SUBJECT: Forwards application for schedular exemption re further analysis of & possible mod to MSIVs & performance of low power physics experiments. All requirements under 10CFR50.12 for issuance of exemption fulfilled.

Re: Nine Mile Point Unit 2  
Docket No. 50-410

APPLICATION FOR SCHEDULAR EXEMPTION  
RELATED TO FURTHER ANALYSIS OF AND POSSIBLE  
MODIFICATION TO MAIN STEAM ISOLATION VALVES

ATTACHMENT 1

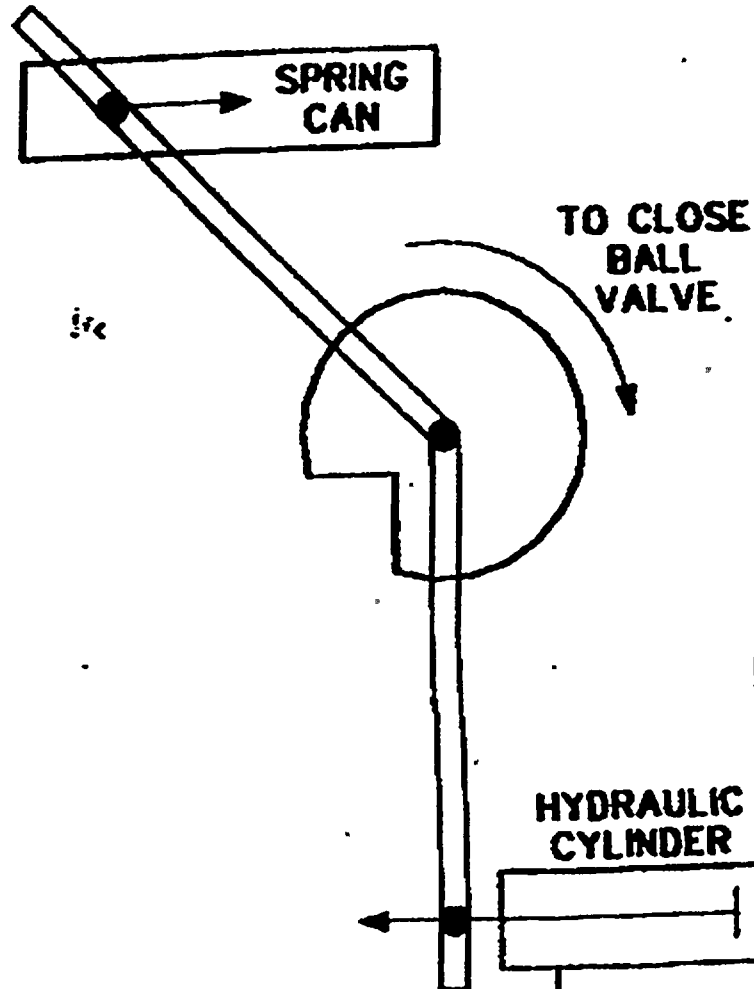
A modification which is being pursued to resolve the MSIV closure problem includes modification of the hydraulic system which is presently used to open the MSIV and allows it to be latched. The hydraulic system would be modified to additionally maintain the MSIV in an open position. By accomplishing this, the present mechanical latching mechanism will not be required.

The hydraulic system solenoid valves will be changed to be continuously energized. In the event of a power failure, the solenoid valve will fail open, thereby causing the MSIVs to close. Additionally, hydraulic failure will cause the spring to close the MSIV thereby maintaining the fail safe feature of the valve.

A sketch is provided, Attachment 1, to depict the modified hydraulic system.

- ELIMINATE TRIP MECHANISM
- HOLD MSIV OPEN WITH CONSTANT HYDRAULIC PRESSURE
